## **STAFF REPORT**

**TO:** Planning Commission  
**FROM:** Ben Hetzel, Lake Elmo City Planner  
**AGENDA ITEM:** **Kokoro Volleyball Conditional Use Permit and Variance**

Raymond Luczak, owner of Kokoro Volleyball, recently submitted a conditional use permit and variance application for a proposed indoor athletic facility at the southeast quadrant of intersection 39<sup>th</sup> Street N and Lake Elmo Avenue N (PID1302921220011). The 27,540 square foot building and parking lot is intended to be a year round volleyball training facility with four full time employees and 52 part time employees. The indoor athletic facility use is permitted by conditional use permit in the zoning district.

**TO:** Planning Commission  
**FROM:** Molly Just, Planning Director  
**AGENDA ITEM:** Schiltgen Farmstead Zoning Map Amendment, Preliminary Plat/Planned Unit Development

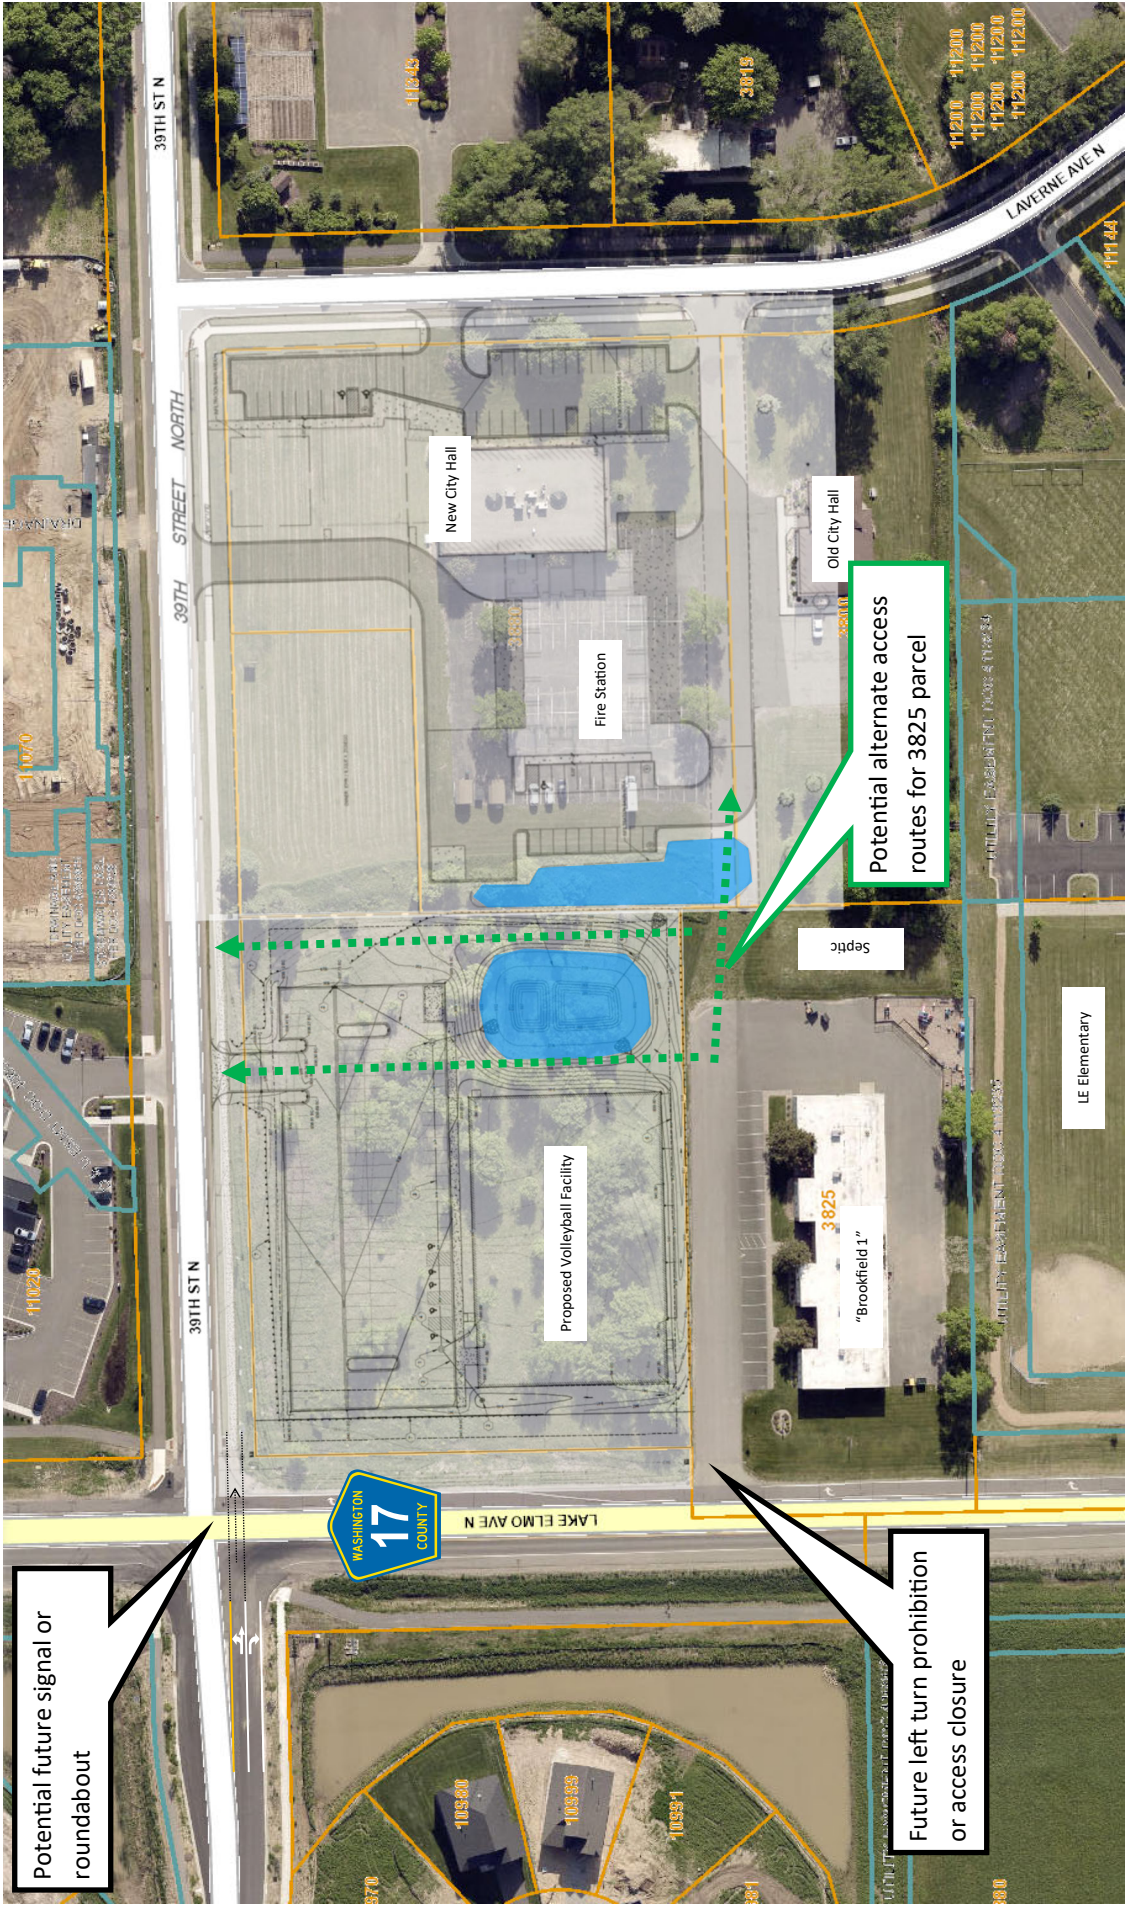
We are concerned that both of these potential routes are planned to be obstructed by stormwater infiltration areas on the Kokoro Volleyball site and on the City Hall/fire station site, as shown on the attached summary diagram.

Future improvements to CSAH 17 in this area, although not yet designed or scheduled, could plausibly include a southward extension of the separated trail along the west side of the roadway, a controlled intersection (traffic signal or roundabout) at 39<sup>th</sup> Street, and/or the raised concrete median mentioned earlier in this letter. Right-of-way for these improvements is currently constrained in this area, with 50 feet of right-of-way from the CSAH 17 centerline. We see and appreciate that the site plan for the volleyball site indicates planned dedication of an additional 25 feet of right-of-way as per the Washington County 2040 Comprehensive Plan.
